UNLIT SUCH TIME AS THESE DRAWINGS ARE APPROVED BY THE APPROPRIATE REVIEWING AGENCIES, JR ENGINEERING APPROVES THEIR USE AS DESIGNATED BY WRITTEN AUTHORIZATION.	PREPARED FOR SR LAND, LLC 20 BOULDER CRESCENT SUITE 201 COLORADO SPRINGS, CO 80903 JAMES F. MORLEY (719) 471-1742
J.R. ENGINEERING A Westman Company Central 303-740-9888 • Colorado Springs 719-583-2593 Fort Collins 970-491-9888 • www.jrengineering.com	
BY DATE	
No. REVISION	
H-SCALE 1"=50'	DESIGNED BY CWC
V-SCALE 1"=5'	DRAWN BY DJG
DATE 11/29/22	CHECKED BY
VOLLMER ROAD (BARBARICK) - INTERIM CONDITION	
INITIAL/INTERIM GESC	
SHEET 2 OF 6	JOB NO. 25188.01

VOLLMER ROAD (BARBARICK)
 -INTERIM CONDITION
 FINAL GESC

VOLLMER ROAD (BARBARICK)
- INTERIM CONDITION
GESC DETAILS
SHEET 4 OF 6
JOB NO. 25188.01

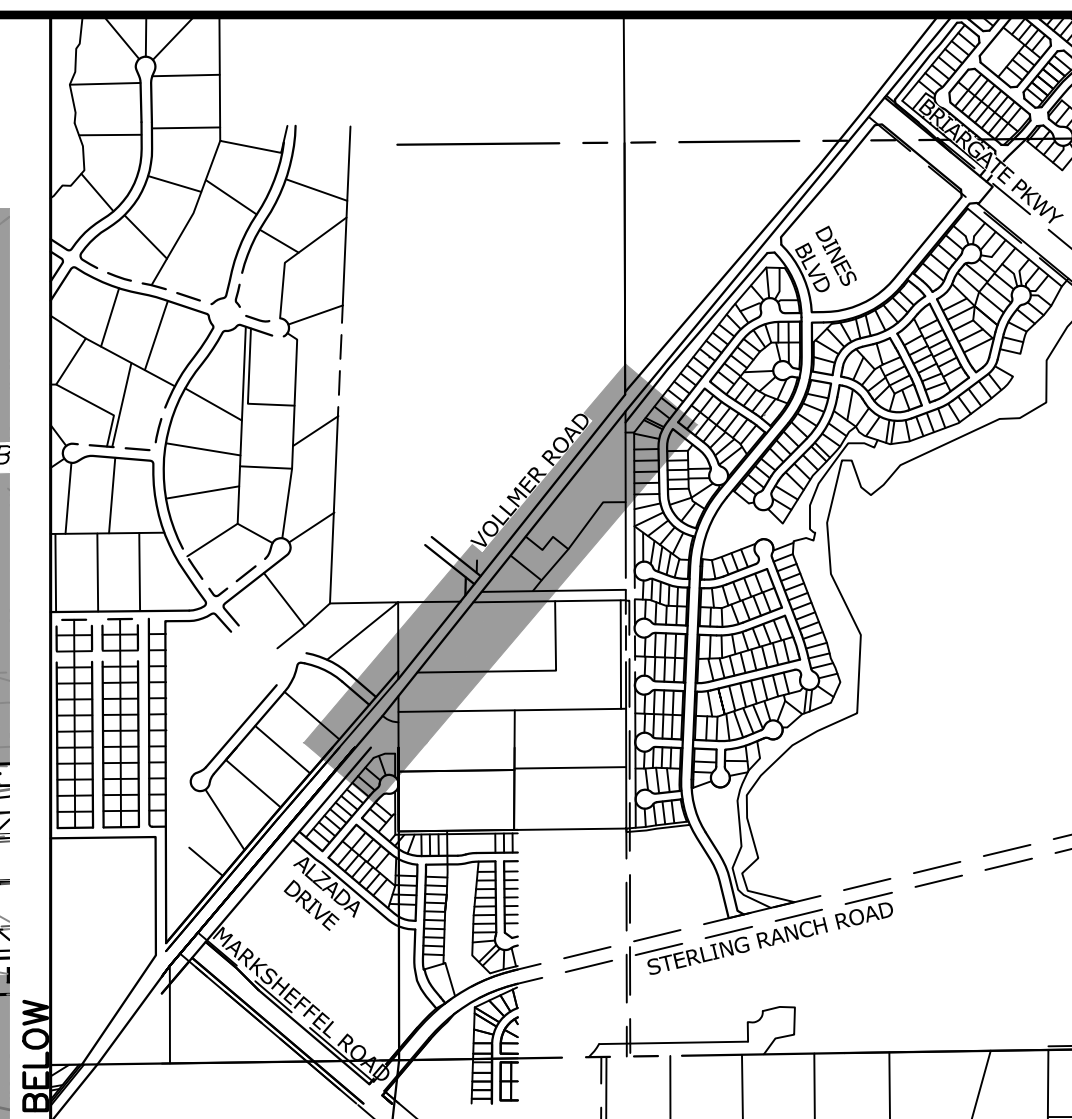
SWMP Checklist Item 17b - Provide stormwater flow direction arrows.

GEC Checklist item b - label all property parcel numbers on all GEC sheets.

size and material for proposed culvert is not shown here or on CDs. Please add.

size and material for proposed culvert is not shown here or on CDs. Please add.

Typical for a GEC sheet: GEC Checklist item v - Label all proposed temporary construction BMPs by phase of implementation (initial, interim).

Provide VTC at this access point of the construction site.

SWMP stated a different percent. Verify and update so both match.

GEC Checklist Item g: Show all existing utilities.

show concrete washout
